CITY OF ALBUQUERQUE

RE: Kraemer Fields
2801 Karsten Court SE
Grading & Drainage Plan
Engineer's Stamp Date: 07/31/20
Hydrology File: M14D012J

Based upon the information provided in your submittal received 08/03/2020, the Grading & Drainage Plan **is not** approved for Grading Permit and Paving Permit. The following comments need to be addressed for approval of the above referenced project:

2 PROPOSED BASIN MAP

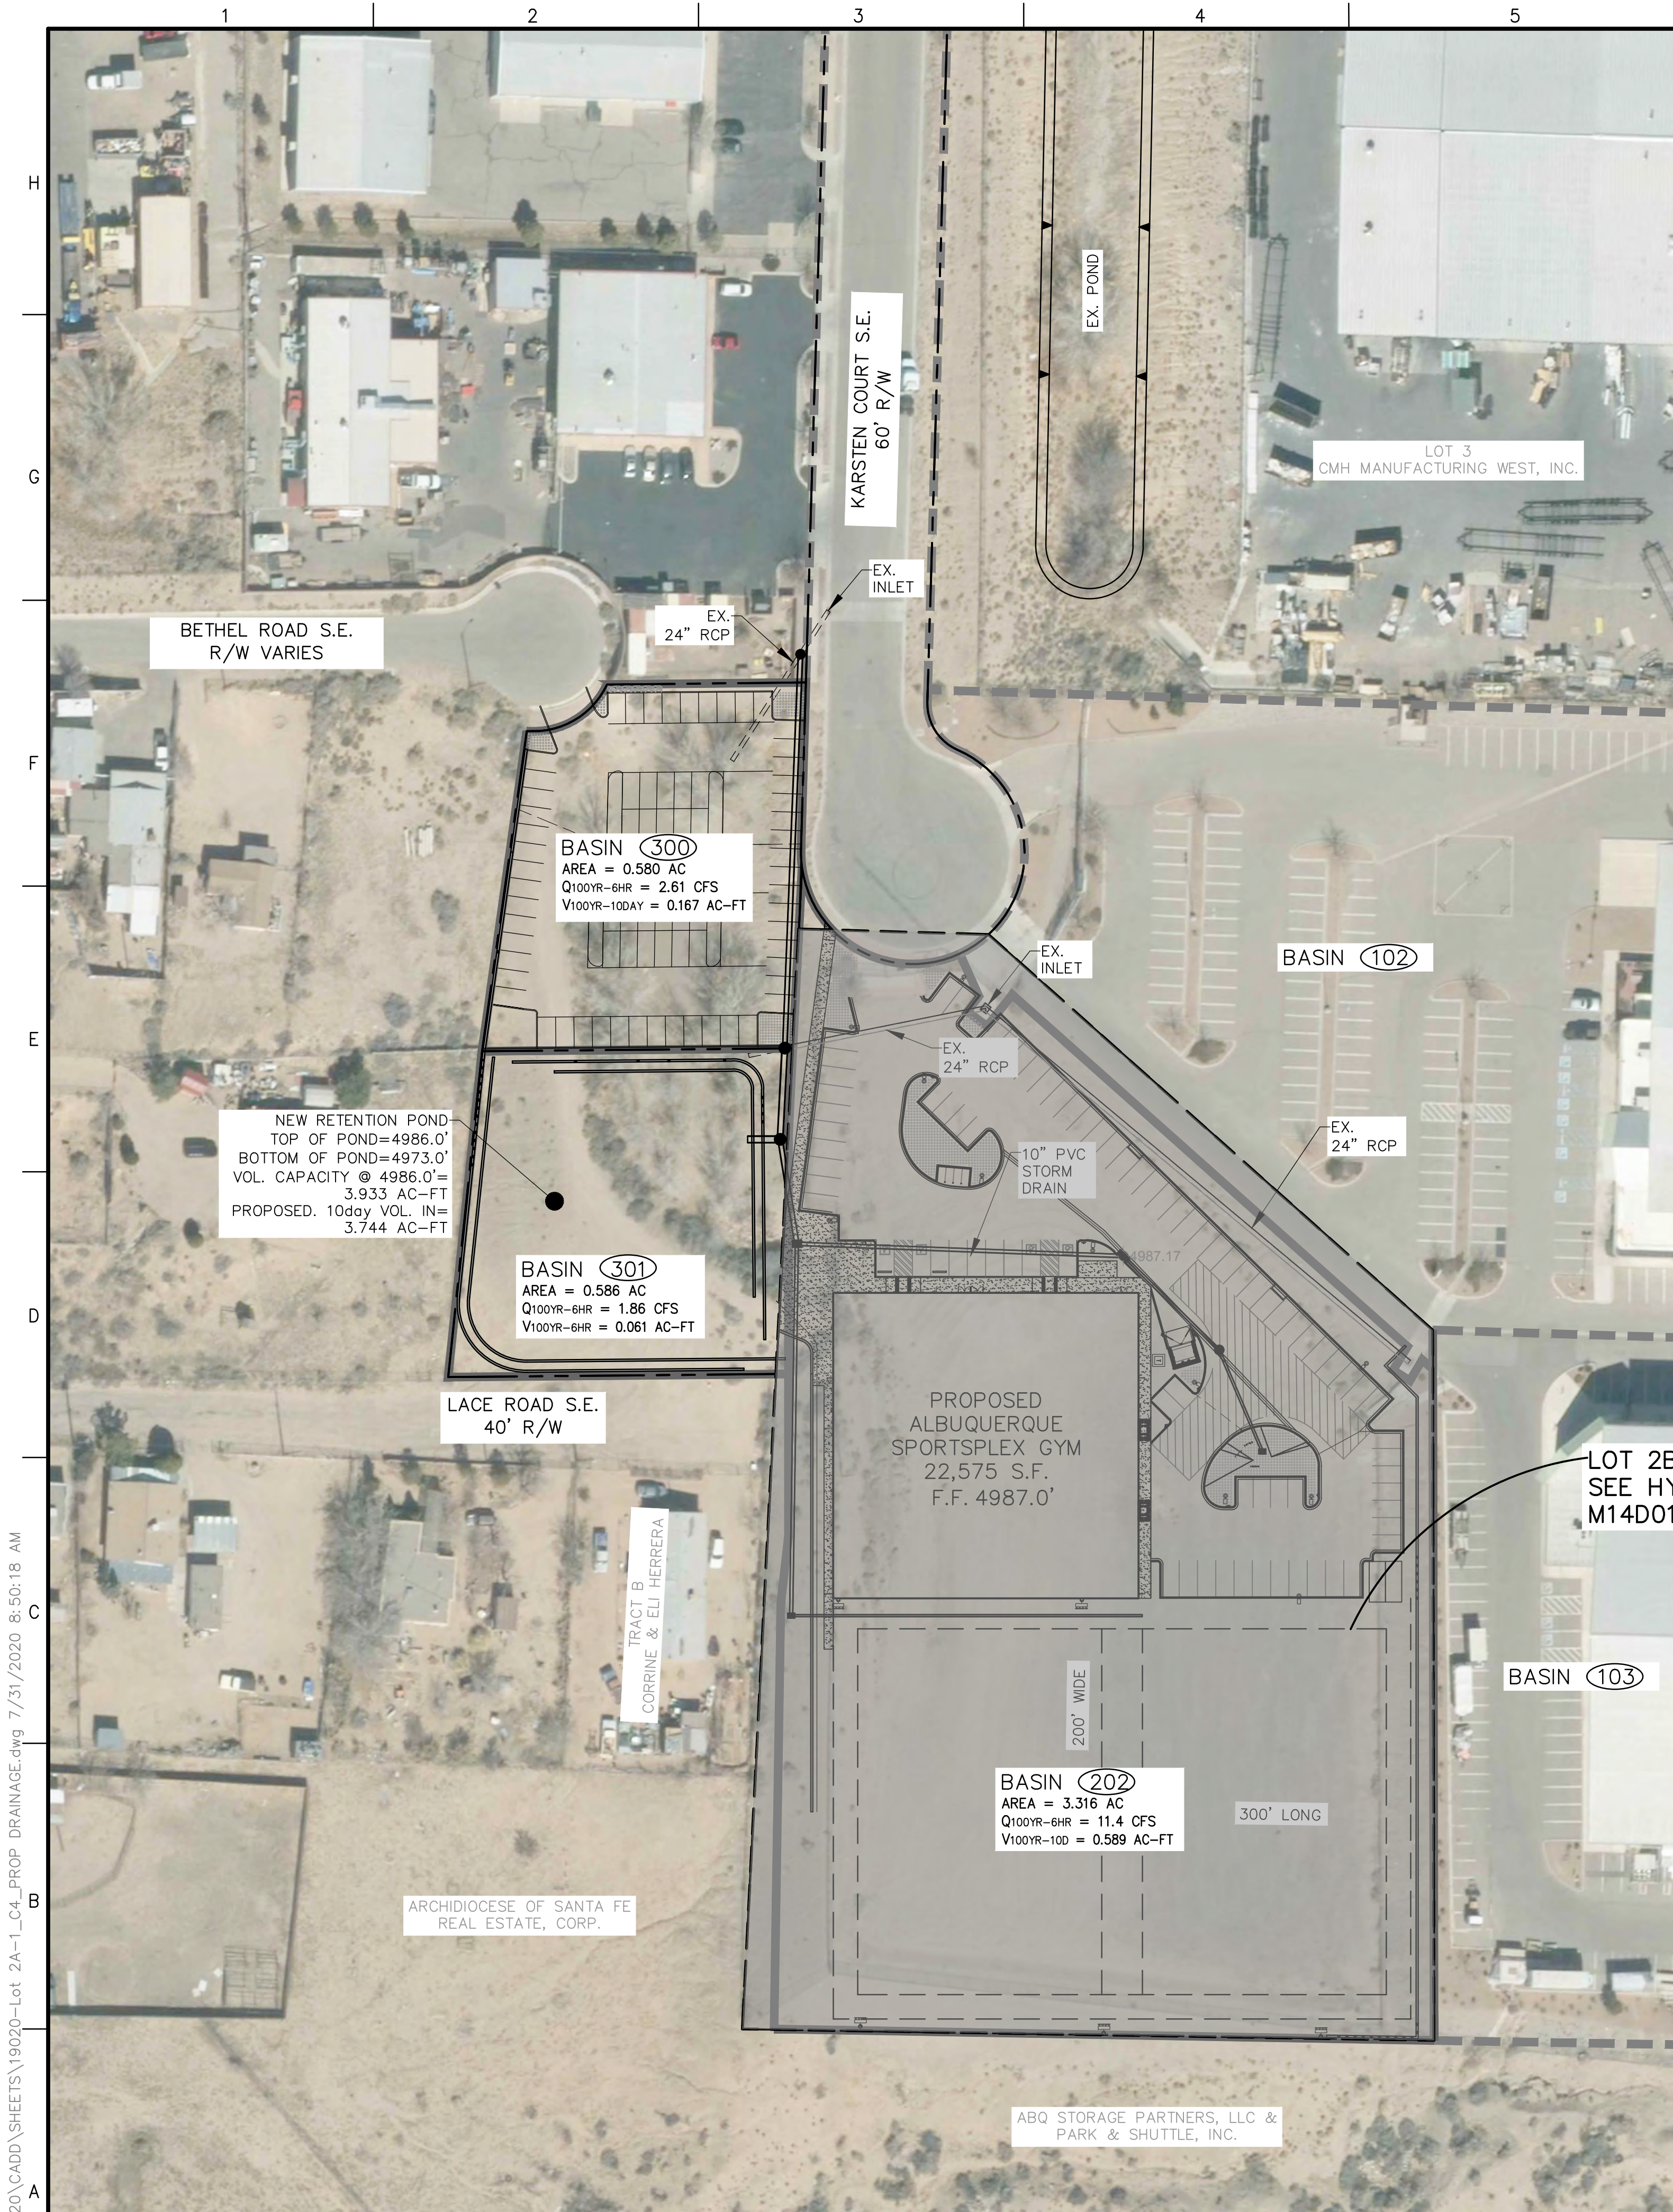
10. Sheet 2. .Please provide an approved City method to water proffing the retaining wall below the WSE of the 100 year 10 day volume.
11. Sheet 4. Basin 300 needs drain into the proposed storm drain as outlined in comment #4. Please show this.
